## HISTORIC AND DESIGN REVIEW COMMISSION

October 03, 2018

**HDRC CASE NO:** 2018-491  
**ADDRESS:** 1010 N HACKBERRY ST  
**LEGAL DESCRIPTION:** NCB 521 BLK 16 LOT S 52.53 FT OF N 100 FT OF 11 ARB 11D  
**ZONING:** IDZ, H  
**CITY COUNCIL DIST.:** 2  
**DISTRICT:** Dignowity Hill Historic District  
**APPLICANT:** Cory Johnson  
**OWNER:** Nicole Johnson  
**TYPE OF WORK:** Rear addition, window and door replacement, fenestration changes.  
**APPLICATION RECEIVED:** September 17, 2018  
**60-DAY REVIEW:** November 16, 2018  
**REQUEST:**

#### RIGHT ELEVATION

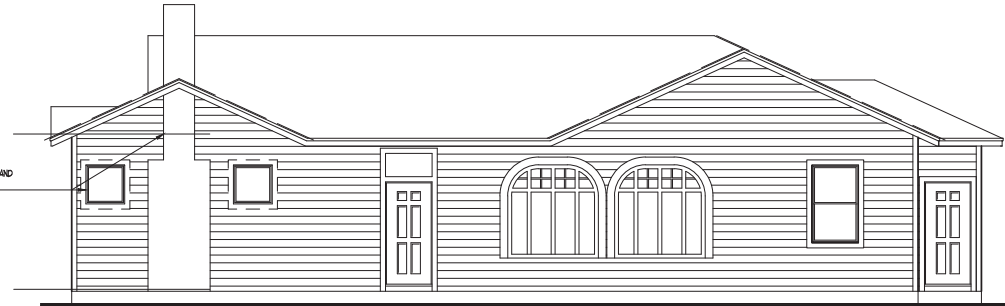
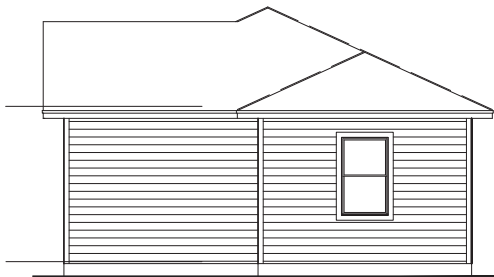
#### **WINDOWS DO NOT ALIGNED WITH OBSERVED ALTERATIONS, INCLUDING ONE WINDOW NOT DEPICTED OR REQUESTING TO BE REMOVED**

Staff comment: (1) The depicted roof form and fenestration does not match the modifications staff observed on site nor the applicants verbal description. (2) The set of arched casement windows are closer to the door, unless the applicant is proposing to relocate the windows (3) The rear gable features a centered set of two-over-two sash windows, unless the applicant is proposing to remove and relocate the windows.

#### LEFT ELEVATION

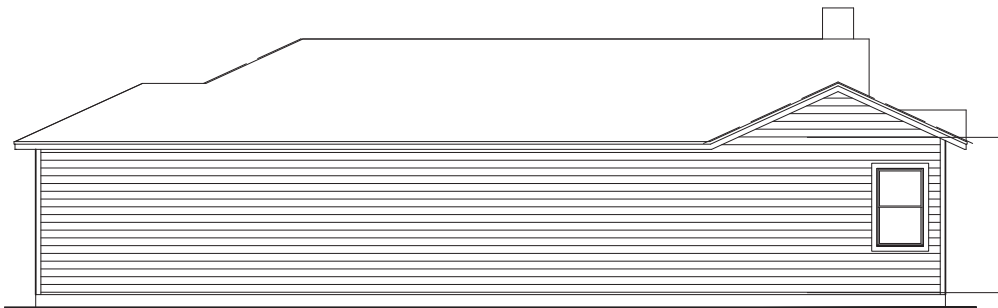
#### **SIX (6) WINDOWS NOT DEPICTED OR REQUESTING TO BE REMOVED**

Staff comment: (1) The depicted fenestration does not match the modifications staff observed on site nor the applicants verbal description. (2) The front gable features two individual one-over-one wood windows, unless the applicant is proposing to remove one. (3) The intermediate wall features two picture windows and a covered sash window, unless the applicant is proposing to remove all three window openings. (4) The rear gable features a set of one-over-one wood windows, unless the applicant is proposing to remove those windows.
